## ***Interactive comment on “On the stability interpretation of Extended Column Test results” by Frank Techel et al.***

**Markus Landrø (Referee)**

Fig. 1.

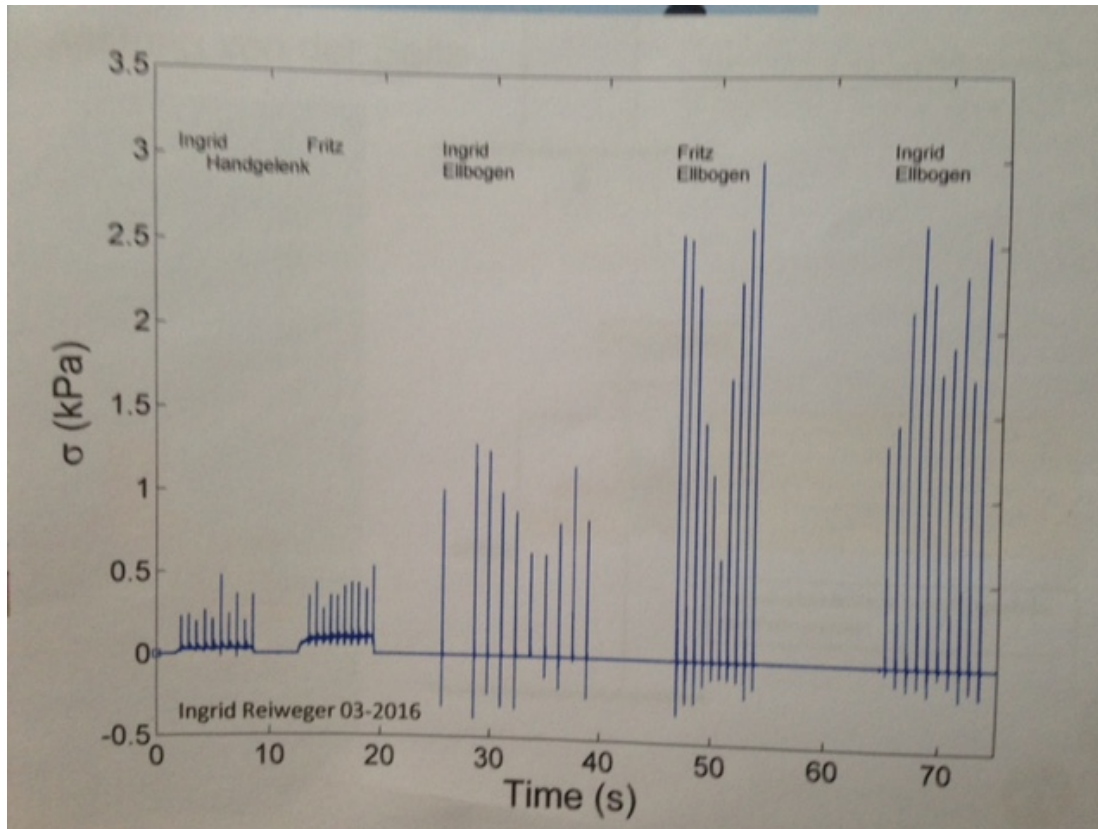
Regarding the vertical vs lateral tapping. My point is to encourage you to discuss the limitations of the ECT even more. Energy absorption is one thing. What about the inconsistency in the tapping itself. See the attached illustration.
